Technical Guidance Committee Meeting

Minutes

Thursday, April 18, 2013

Figure 4-20. Pump to drop box detail.

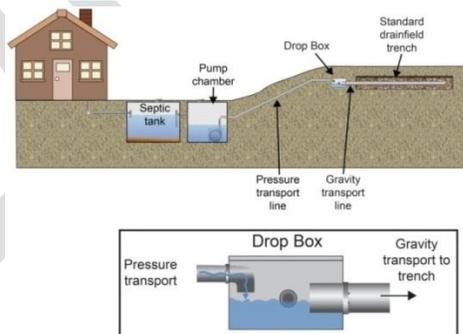
- Engineering requirements for pump to drop box systems is an unnecessary hardship on homeowners and does not benefit public health.
- Section 4.20.3.5 In-Tank Pumps allow for a maximum dose of 120 gallons at a rate up to 30 GPM. In the proposed pump to drop box section the pump rate is restricted to 10 GPM, and there is also an additional restriction for effluent velocity between 2 & 4 fps. This will dictate the diameter of the pipe. At 30 GPM a 2 inch pipe flows at 3.1 fps and a 1 inch pipe flows at 12.2 fps. At 10 GPM a 2 inch pipe flows at 1 fps and a 1 inch pipe flows at 4.1 fps. Will this cause a problem?

The Committee removed the requirements that pumps should be sized to effectively deliver a maximum dose of 120 gallons with a maximum pump rate of 10 GPM and that effluent velocity in the pressure transport line should be between 2-4 feet per second. The recommendation for use of an engineer in pump to drop-box design was amended to elevation gains of greater than 100 feet and lengths of greater than 500 feet.

Figure 3-3. Overhead view of equal distribution methods.

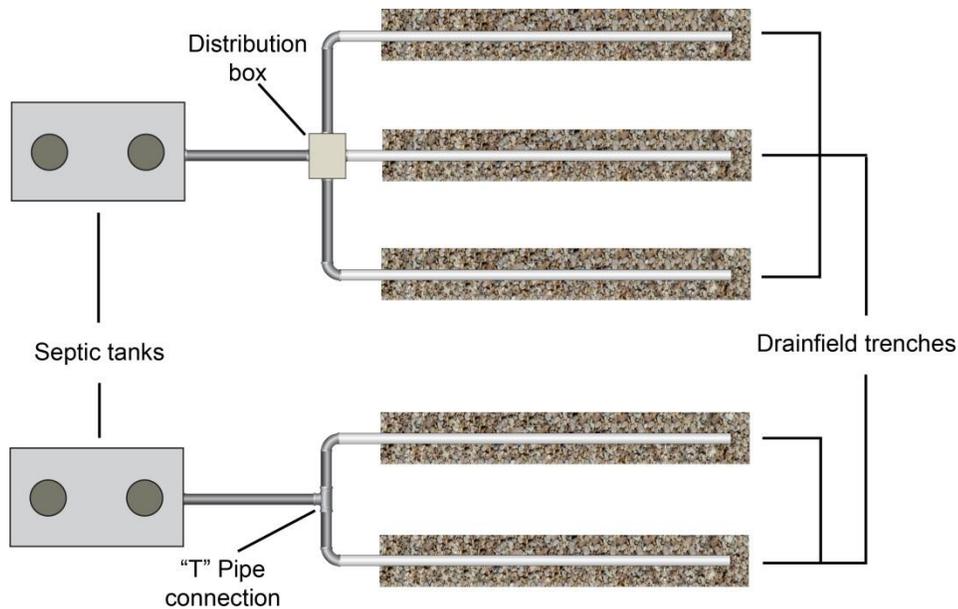
- The Committee requested additional figures be developed for these two sections to better convey equal distribution.
- The Committee requests that DEQ obtain the failure data from the health district submitting the public comment regarding equal and serial distribution systems.

Figure 3-1. Dimensional Horizontal separation distance requirements for a standard drainfield (IDAPA 58.01.03.008.02.d and 58.01.03.008.04).

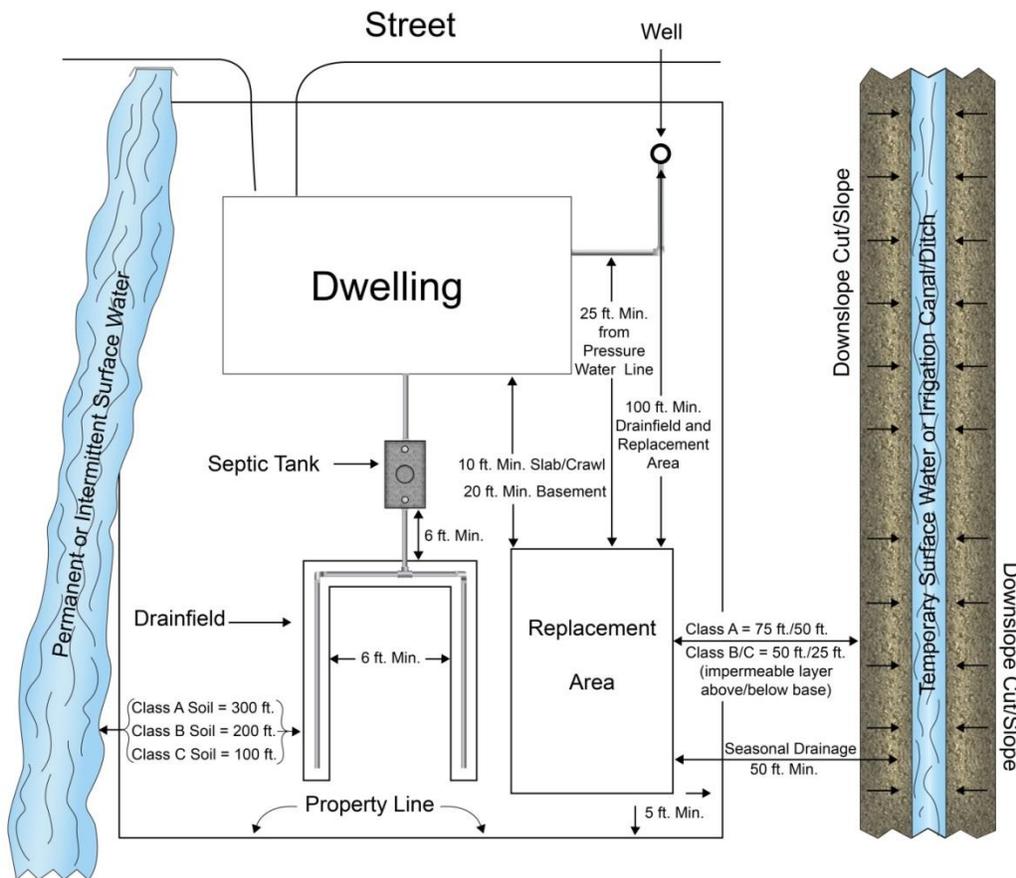
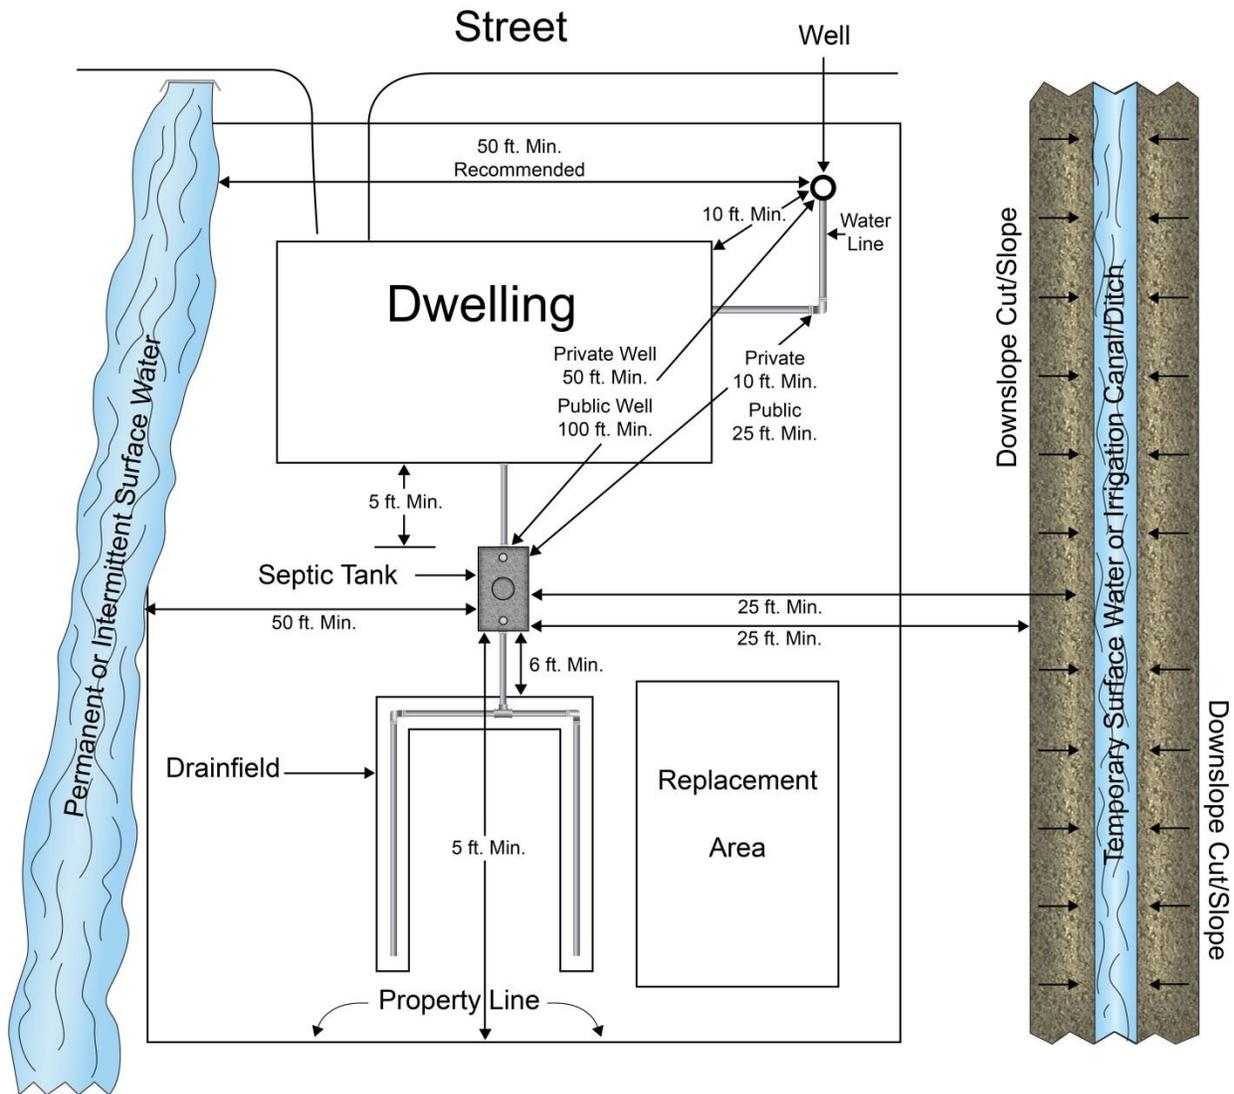
The Committee made several recommendations for amendments to figures 3-1, 3-2, and 3-3. These were incorporated as action items for the next meeting.

- Amend figures 3-1, 3-2, and 3-3 as follows:
 - 3-1: Amend the Soil Design Class to Soil Design Group
 - 3-1 and 3-2: Move the discharge pipe to the center of the U-shaped drain field
 - 3-1 and 3-2: Change Seasonal Drainage to Temporary Surface Water
 - 3-1 and 3-2: Change Downslope Cut/Slope to Downslope Cut/Scarp
 - 3-1 and 3-2: Adjust trenches so they are not connected at top
 - 3-1: Work on adjusting the scarp setbacks
 - 3-2: Move 5 foot minimum from the side of the septic tank, not through drainfield
 - 3-1: Add designation of 6 foot minimum from the side of the drain field and replacement area
 - 3-3: Make one of the access lids to the septic tank larger than the other
 - 3-3: Remove 2 foot minimum from above the drain field
 - 3-3: Add to the 1 foot minimum cover, a 3 foot max cover limit
